1998 - 1999 Corvette: Service Bulletin: Tech - Service Engine Soon (SES) Light Illuminates (Repl Switch Assy)

Source: Chevrolet Dealer Technical Service Bulletin

Number: 99-07-30-013

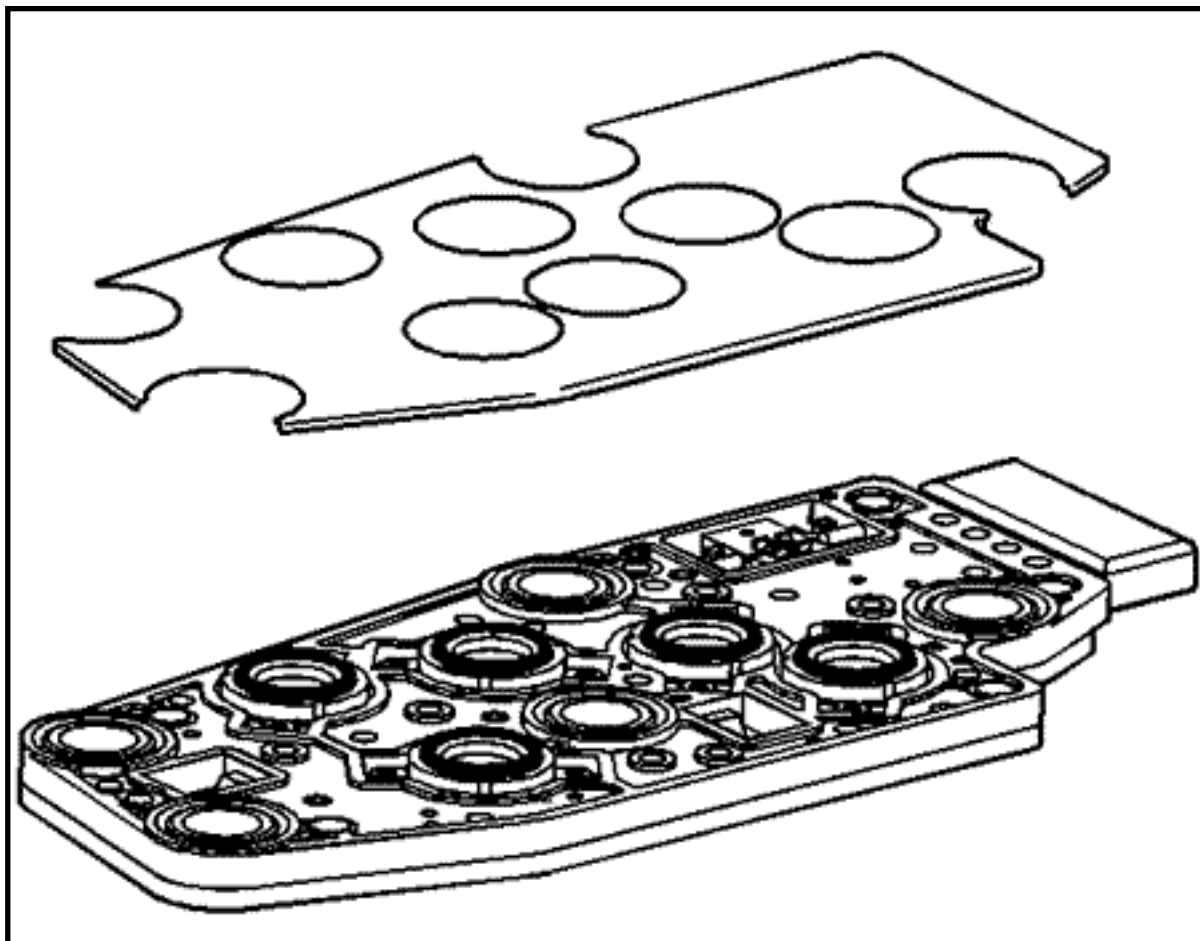
Debris from aluminum shavings, bronze material, and certain clutch material may cause the pressure switches in the TFP switch assembly to stick or electrically short out.

A new TFP switch assembly with a plastic shield has been released. The plastic shield is designed to protect the pressure switch from debris. This improvement will reduce the likelihood of a DTC P1810. This product change went into production on April 8, 1999 (Julian date 098). The existing TFP switch assembly remains relatively unchanged except for the addition of the new shield, creating a new part number for the assembly. The shield fits over the existing TFP switch assembly and is not sold separately.

Follow diagnostics for the P1810 Diagnostic Trouble Code in the Transmission Section of the appropriate Service Manual. If the diagnostics indicate that switch replacement is necessary, use the correct switch P/N as listed below.

Part Number	Usage	Description
24215111	1998-1999	TFP Switch Assembly with Shield
